# Access Compliance Report

## Public Rights-of-Way

### (Curb Ramps)

Intersection ID: 10042418	Main Street: YANCEY_RD	Cross Street: N/A	Location: S
ADA ID: 799EBCA38A63	Ramp Type: Para	Initial Pass/Fail: Fail	Overall Compliance: No
		Severity Score: 12.5	
Codes/Mitigation Info/Possible Solution		Field Measurements/Component Compliance

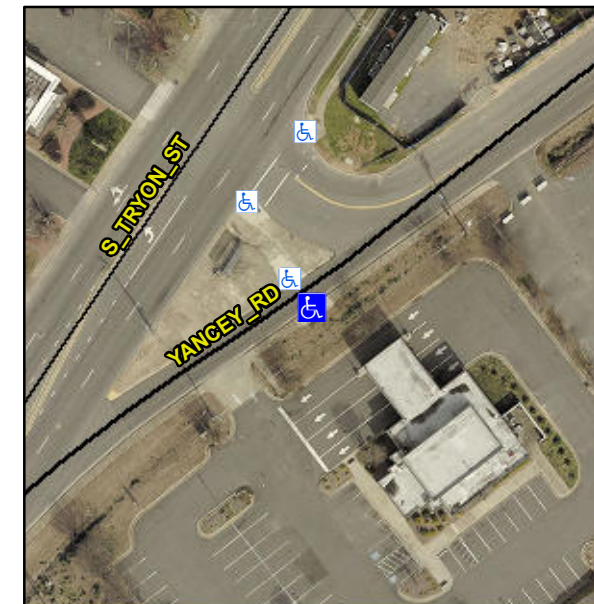
**LT RP < 5%**

**R304.3.2**

Compliance	Description	Data	Compliance	Description	Data
N/A	Ramp Length LT (in)	84.0	N/A	Ramp Length RT (in)	86.0
Yes	Ramp Width LT (in)	58.0	Yes	Ramp Width RT (in)	58.0
Yes	Ramp Slope LT (%)	2.8	No	Ramp Slope RT (%)	11.2
Yes	Ramp XSlope LT (%)	0.5	Yes	Ramp XSlope RT (%)	0.6
N/A	Landing Length (in)	N/A	N/A	DWS Provided?	N/A
N/A	Landing Width (in)	N/A	N/A	DWS Contrast?	N/A
N/A	Landing Slope (%)	N/A	N/A	DWS Length (in)	N/A
N/A	Landing X Slope (%)	N/A	N/A	DWS Full Width?	N/A
N/A	Landing Curb? (Y/N)	N/A	N/A	DWS Offset (in)	N/A
N/A	Shared Landing?	N/A			
N/A	Gutter Ponding?	N/A	N/A	Gutter Slope (%)	N/A
N/A	Gutter Lip Ht (in)	N/A	N/A	Gutter X Slope (%)	N/A
N/A	Painted X Walk1?	No	N/A	Painted X Walk2?	N/A
	X Walk 1 Direction	To NW		X Walk 2 Direction	N/A
N/A	X Walk 1 Width (in)	N/A	N/A	X Walk 2 Width (in)	N/A
	X Walk 1 Slope (%)	4.8		X Walk 2 Slope (%)	N/A
	X Walk 1 X Slope (%)	3.8		X Walk 2 X Slope (%)	N/A
N/A	Ramp inside XWalk1?	N/A	N/A	Ramp inside XWalk2?	N/A

**Remove & Replace Entire Ramp.**
